LS2085_88ARDBE

LS2085A/LS2088A Reference Design Board Errata

Rev. 3 — 28 May 2021

Errata

Figure 1. E-00001 workaround

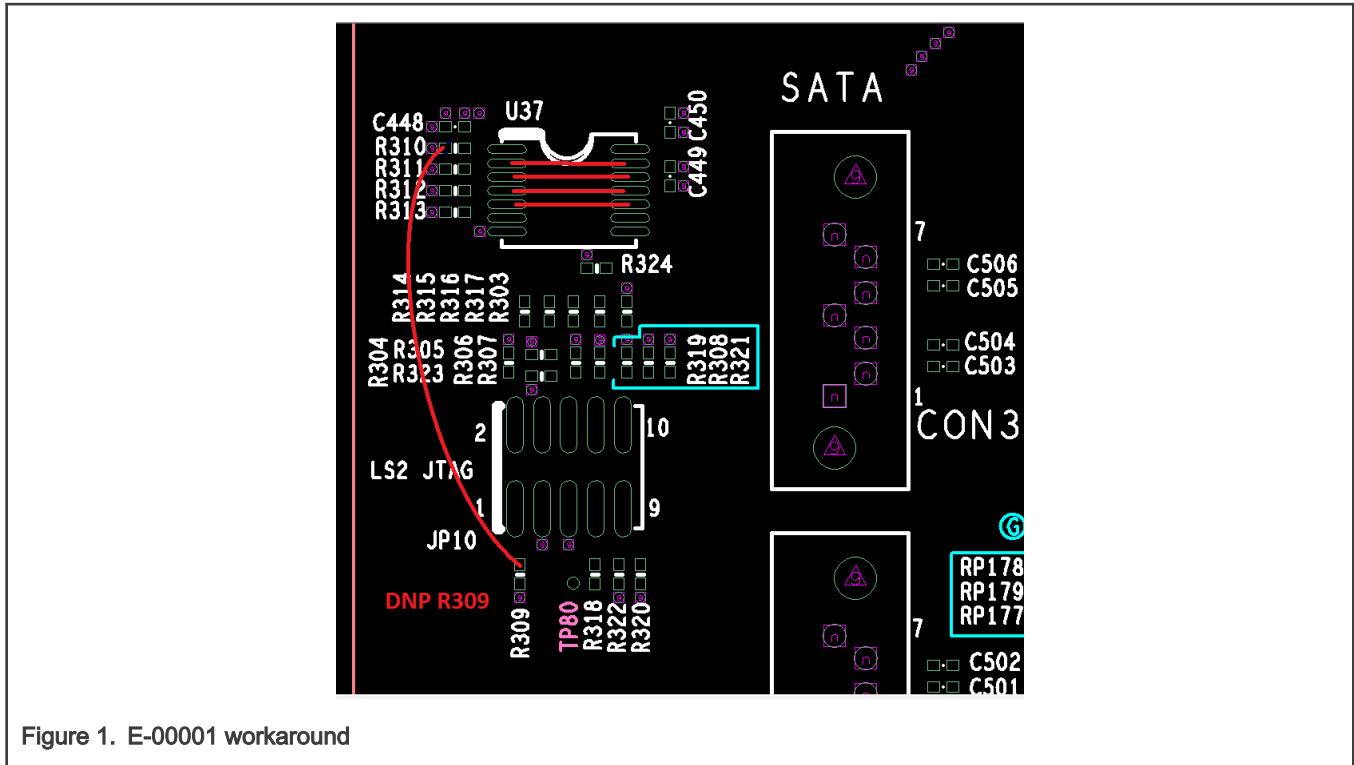
E-00001: JTAG voltage translator U37 is not required

The U37 voltage translator impacts the signal integrity of the JTAG bus.

The CodeWarrior TAP device does not work with the U37 voltage translator installed on the board.

Remove the U37 voltage regulator and R309 resistor and solder the wires as listed below.

- R310 pin 1 to R309 pin 1
- U37 pin 2 to U37 pin 13
- U37 pin 3 to U37 pin 12
- U37 pin 4 to U37 pin 11
- U37 pin 5 to U37 pin 10

The above mentioned rework has been implemented on all Rev B boards. The permanent fix will be available on Rev. C boards.

Figure 2. E-00002 workaround

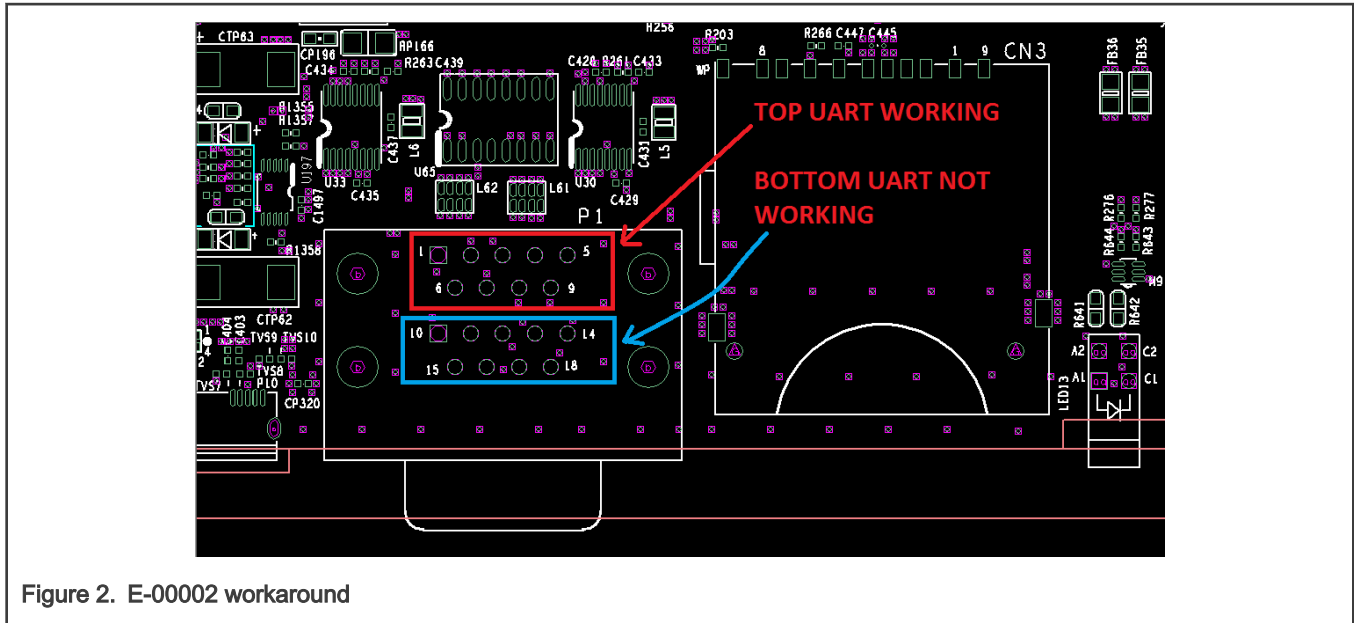
E-00002: COM1 (UART 1/3) port is not working

The bottom port UART 1/3 is not working. It is wired incorrectly.

User cannot use the bottom port, UART 1/3.

Use the UART 2/4 top port.

The issue will be fixed on Rev. C boards.

Figure 3. E-00005 workaround

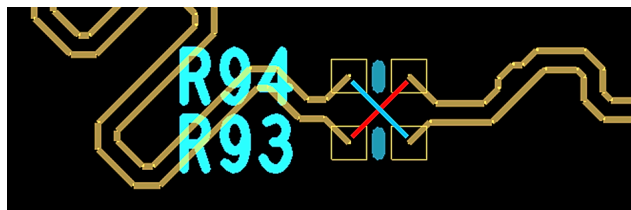
E-00005: DDR4 connector U6 signals D2_MCLK1P and D2_MCLK1N are reversed

The D2_MCLK1P and D2_MCLK1N signals are mistakenly reversed in the schematic and in the layout.

The DDR controller 2 will not work. The errata impacts Rev. B and Rev. C boards.

Remove the R93 and R94 resistors and solder jumpers as listed below.

- R93 Pin1 to R94 Pin2 (need posted insulating tape)
- R94 Pin1 to R93 Pin2

All Rev B and Rev C boards will have this rework implemented before shipping. Therefore, no visible impact to the end user. The permanent fix will be implemented on Rev. D boards.

Figure 4. E-00006 workaround

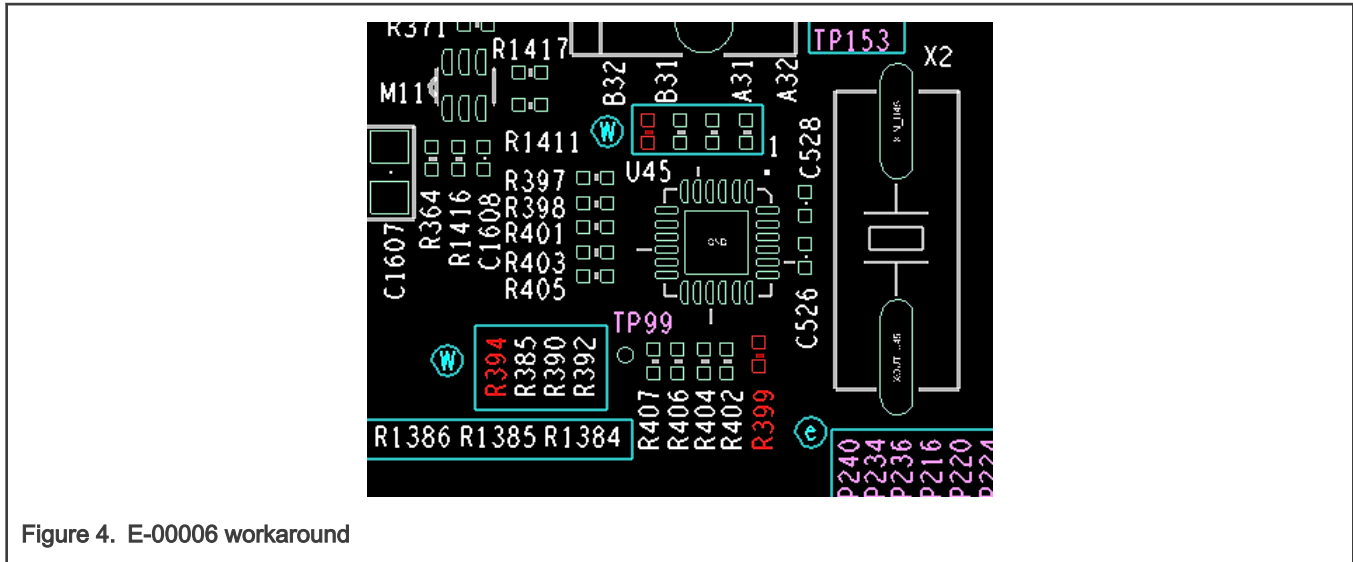
E-00006: Clocks are not generated properly to PCIe slots

The 100 MHz clocks are not generated properly to the PCIe slots.

The x8 and x4 PCIe slots are not operational.

Remove the R399 and R394 resistors.

All Rev. B and Rev. C boards will have this fix implemented before shipping. Therefore, no visible impact to the end user. The permanent fix will be implemented on Rev. D boards.

Figure 5. E-00007 workaround

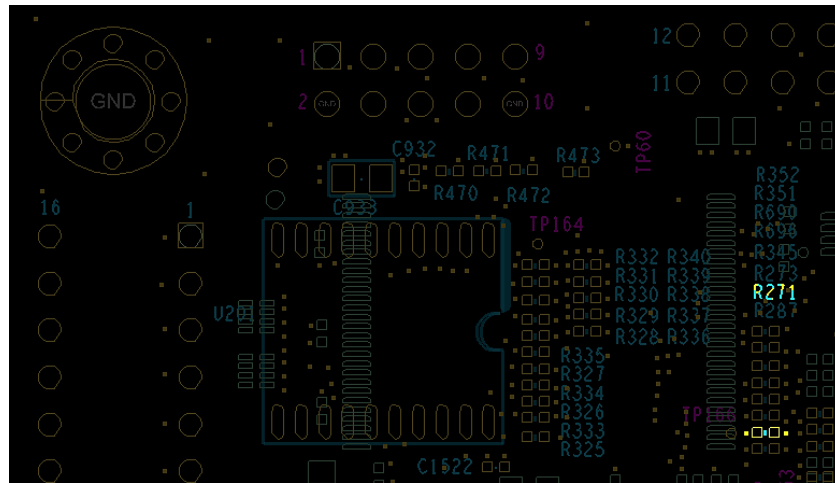
E-00007: CFG_TESTSEL_B cannot be driven low

CFG_TESTSEL_B has both, a weak pulldown and a stronger pull-up. The SW8[5] switch cannot affect the TESTSEL level.

The alternate LS2085A/LS2088A personalities cannot be selected.

Rev. B/C: Remove the R271 resistor from the bottom of the board as shown in the image below.

Rev. D and later: Use CPLD v1.18 or later. The R271 resistor does not need to be removed.

Figure 6. E-00008 workaround

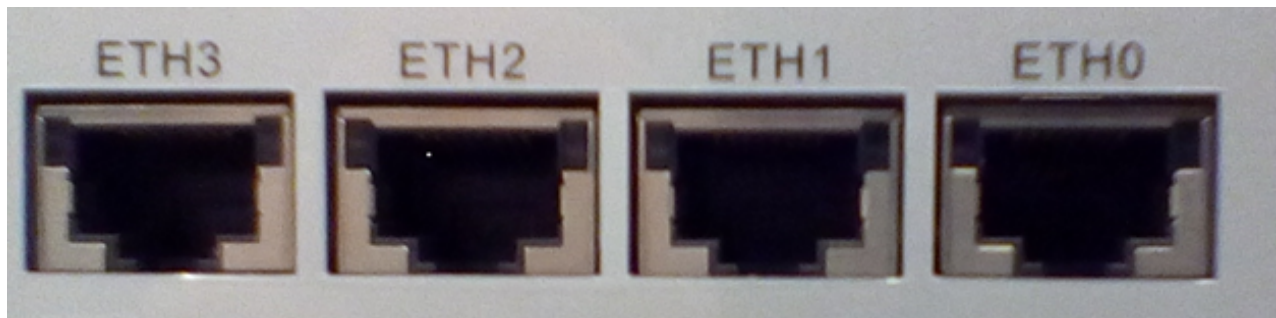
E-00008: Only two 10 Gbit Ethernet copper ports can operate at a time

The power supply to the Aquantia 10 Gbit Ethernet PHY is inadequate on Rev. B and Rev. C boards. As a result, only two 10 Gbit Ethernet copper ports can be enabled at a time instead of all four copper ports.

Any two 10 Gbit Ethernet copper ports can be used or enabled under this restriction. The LS2085A/LS2088ARDB software enables the ETH0 (DPNI7) and the ETH2 (DPNI9) copper ports by default.

No viable workaround to enable all four Ethernet ports. User is restricted to use only two 10 Gbit copper ports at a time. Currently, the software enables the ETH0 (DPNI7) and ETH2 (DPNI9) ports by default.

The power supply is fixed on Rev. D and later boards. Therefore, all four 10 Gbit Ethernet copper ports can be used on Rev. D and later boards with no port restrictions.

Figure 7. E-00009 workaround

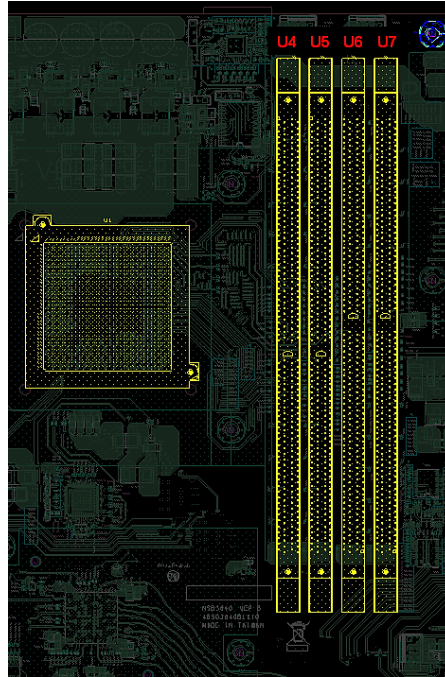
E-00009: DDR rate is limited to 1866 MT/s when a single DIMM is installed

The DDR only operates at a 1866 MT/s maximum rate when a single DIMM is installed (for each controller). Rev. C and earlier boards do not support two DIMMs per controller due to the erratum E-00004.

On Rev. E and later boards, U4 location is swapped with U5 location. Similarly, U6 location is swapped with U7 location. The figure below shows the swapped locations.

For Rev. C and earlier boards: No workaround. The boards are limited to work on one DIMM per controller at a maximum rate of 1866 MHz.

For Rev. D boards: No workaround. Either one or two DIMMs per controller is supported; DDR rate is 1866 MT/s.

For Rev. E and later boards: Two DIMMs per controller is supported; DDR rate is 1866 MT/s. One DIMM per controller is supported; DDR rate is 2133 MT/s.

Figure 8. Rev. E and later boards: DDR DIMMs

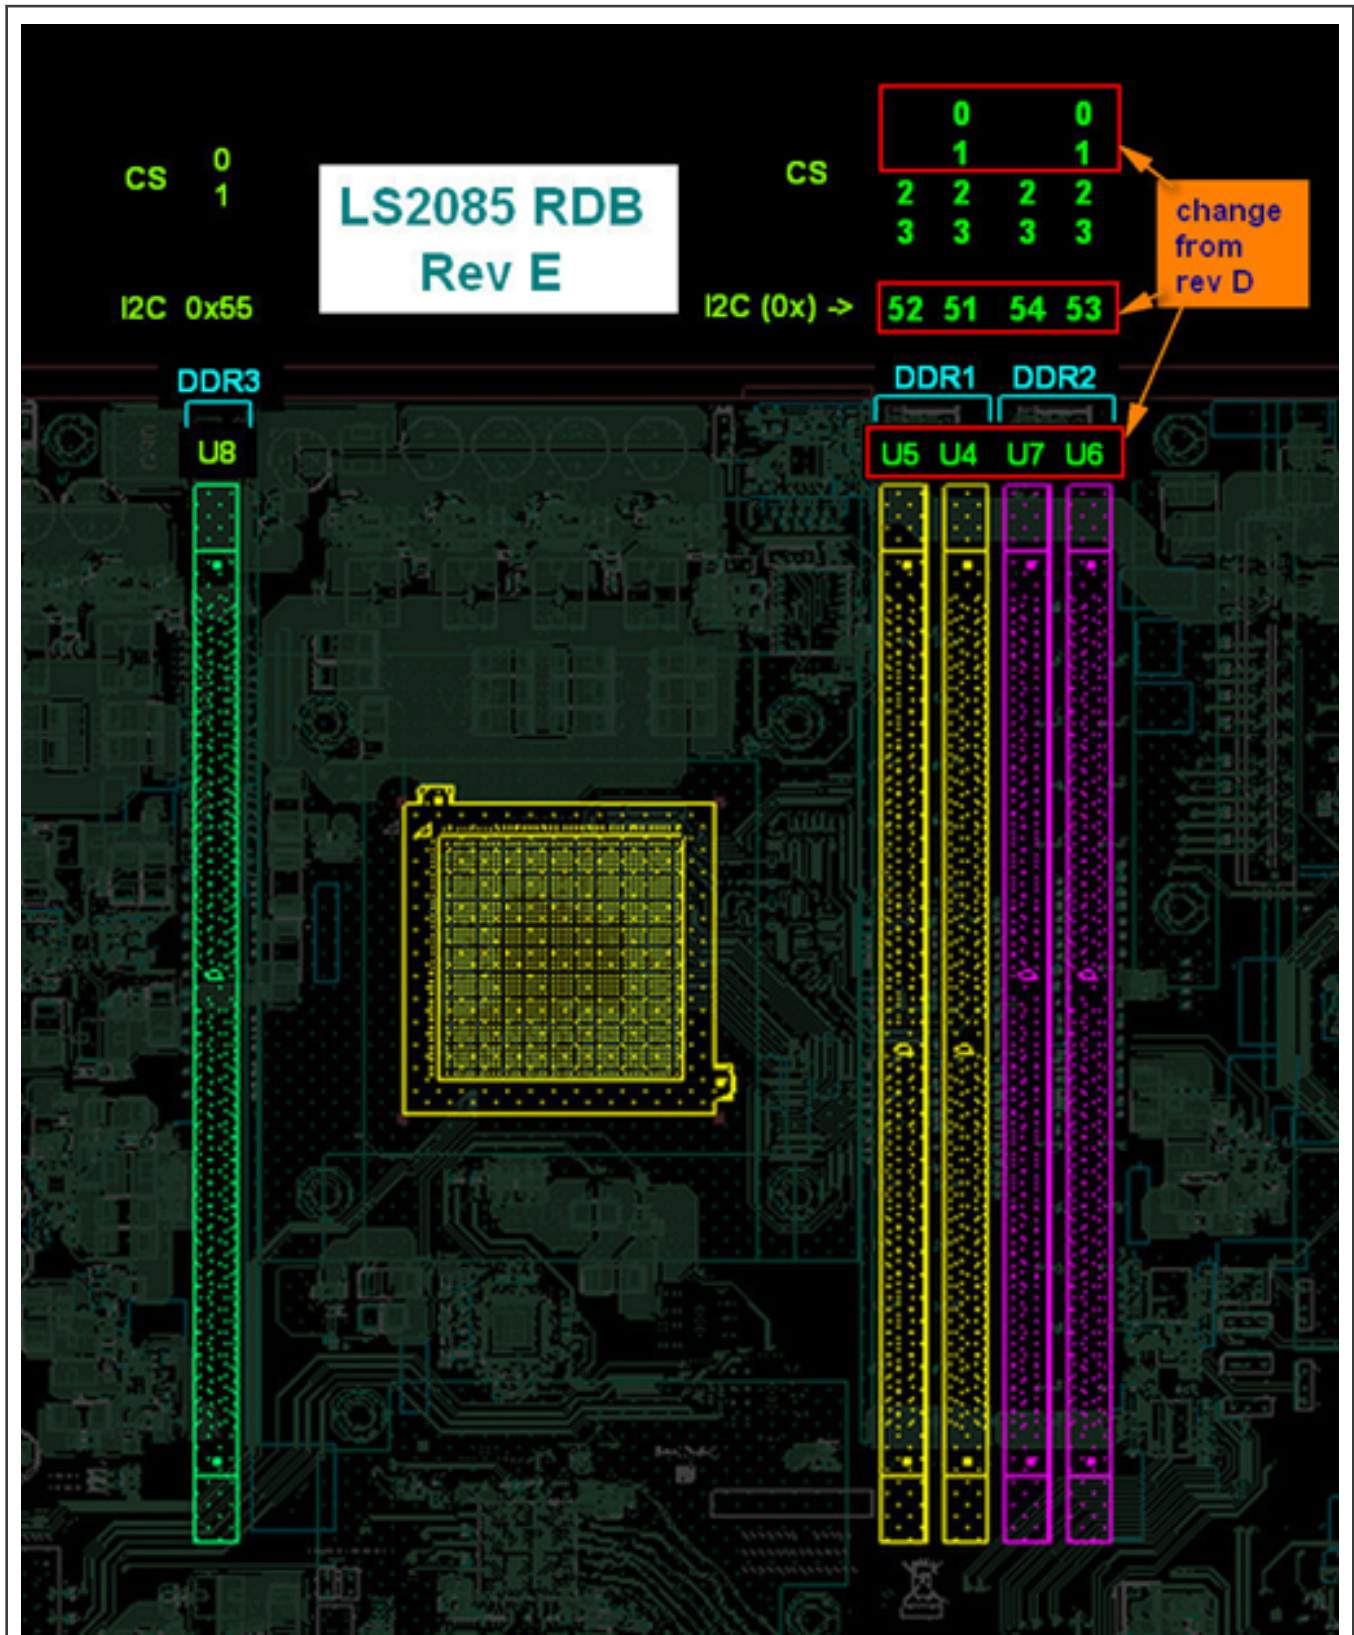
On Rev. E boards, DDR operation at 2133 MT/s requires the removal of DIMM at U5 (for DDR controller 1) and U7 (for DDR controller 2). The DDR DIMMs are relocated and rewired on Rev. E and later boards to provide optimal DIMM location signaling. The Figure below shows the changes in the DDR DIMM locations for Rev. E and later boards. Basically, U4 – U7 have been repositioned to provide optimal signal integrity when only one DIMM is installed. When installing one DIMM per controller to achieve 2133 MT/s speed, the DIMM should be installed at location U4 (for DDR controller 1), and at U6 (for DDR controller 2).

Figure 9. E-00011 workaround

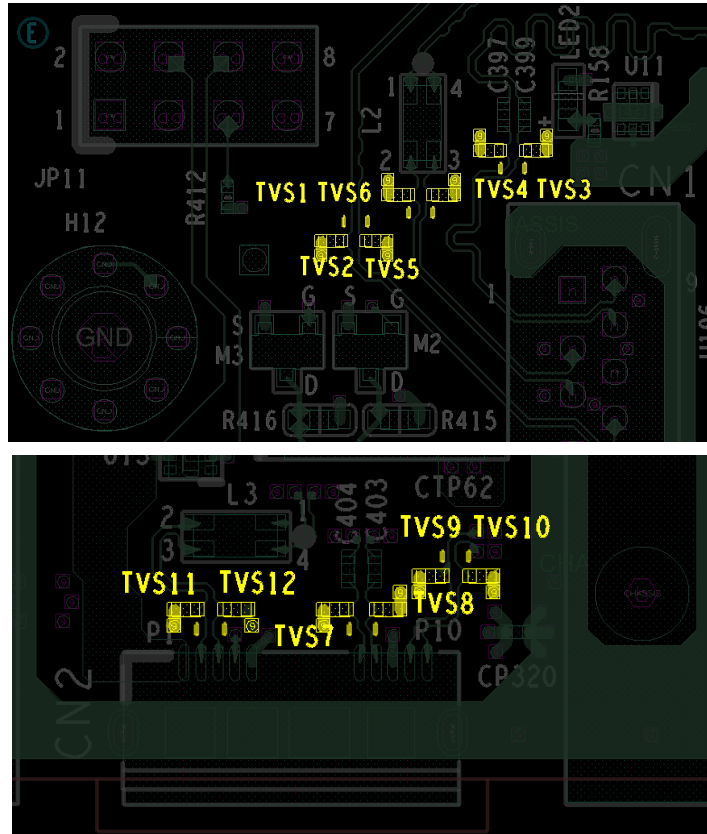
E-00011: USB 3.0 SuperSpeed devices train only to USB 2.0 (high speed) mode

On both USB ports, the USB 3.0 devices (SuperSpeed devices) detects in a USB 2.0 (high speed) mode. SuperSpeed = 5 Gbit/s, high speed = 480 Mbit/s. The ESD protection devices (AZ4012-01F) have excessive loading capacitance (40-50 pF).

The USB 3.0 devices will not train at the SuperSpeed mode (5 Gbit/s) and fall back to 480 Mbit/s.

Remove the ESD protection devices, TVS2 to TVS5 and TVS7 to TVS10. This solution is required for Rev. C and earlier boards. No change is required on Rev. D boards as these ESD protection devices have already been removed from the board during the assembly process before shipping.

Figure 10. LS2085A/LS2088ARDB Rev. E and later boards: USB protection diodes

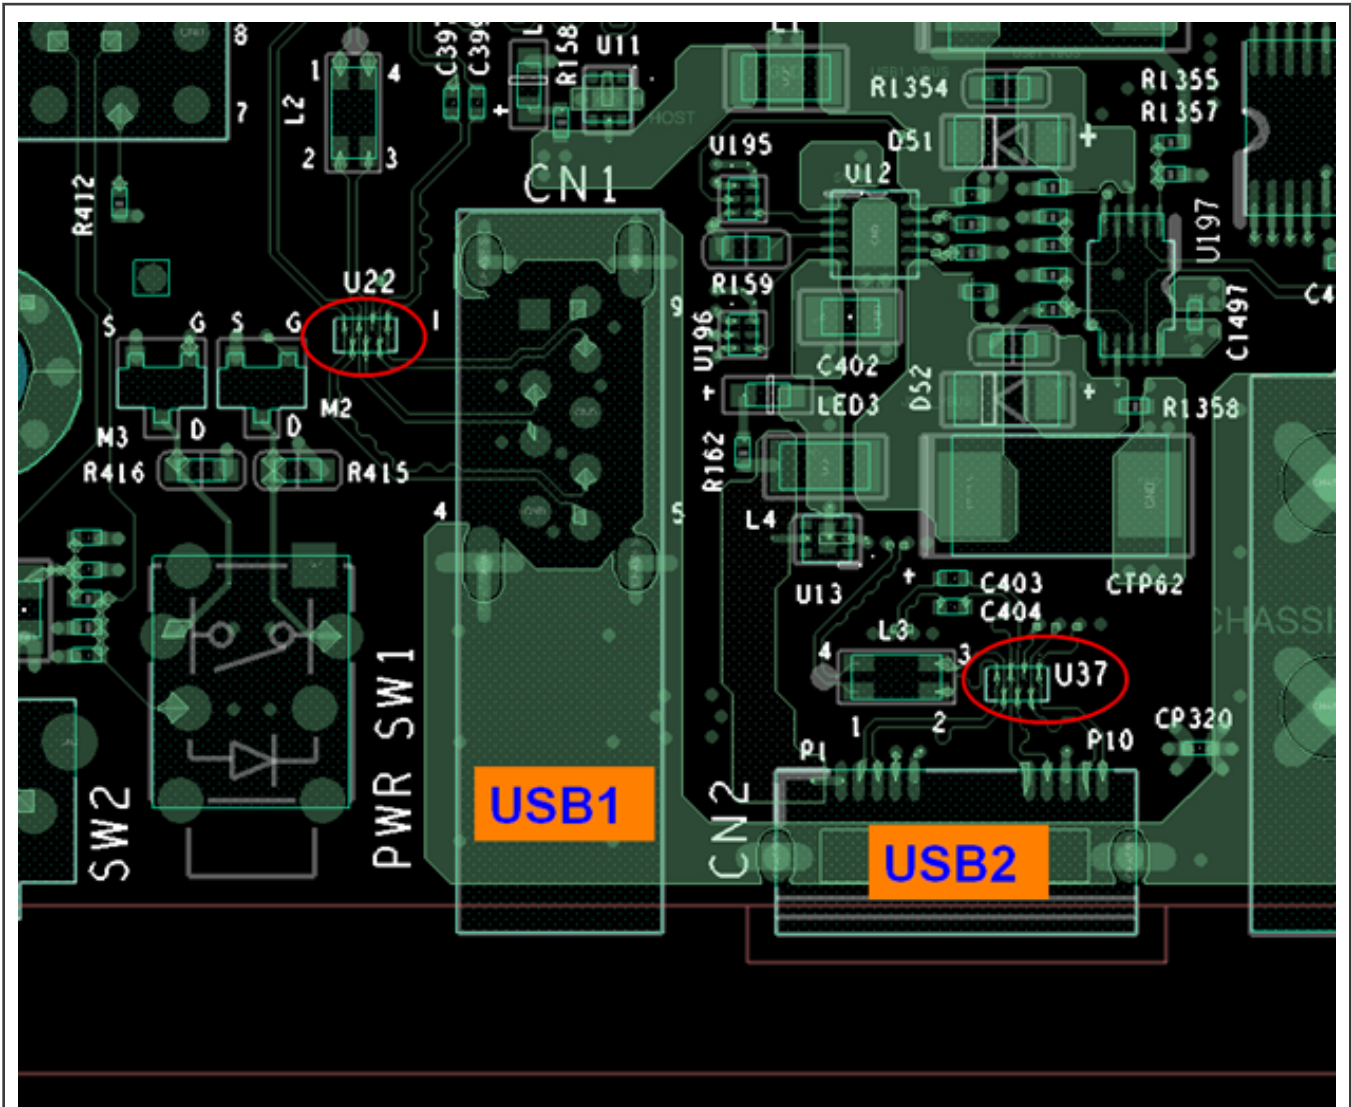
For Rev. C and earlier boards, remove the ESD protection devices, TVS2 to TVS5 and TVS7 to TVS10. For Rev. D boards, these ESD protection devices have already been removed. The permanent fix will be implemented on Rev. E and later boards as listed below.

- Replace all ESD protection diodes TVS1 to TVS13 on the USB interface, with the lower load capacitance diodes (0.2 pF).

Rev. E and later boards have NXP PUSB3FR6Z ESD protection diodes at location U22 and U37 as shown in below figure:
